Access Compliance Report Public Rights-of-Way (Curb Ramps)

Intersection ID: 28056Main Street:BLAKENEY_HEATH_RDCross Street:ELLINGTON_PARK_DRLocation:NEADA ID: 216F102F6304Ramp Type:Directional1Initial Pass/Fail:FailOverall Compliance:NoSeverity Score:12.5

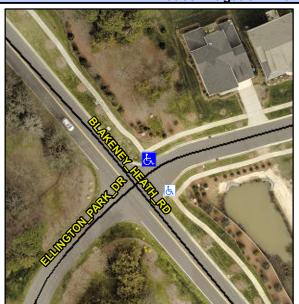
R304.2.2

Remove & Replace Entire Ramp.
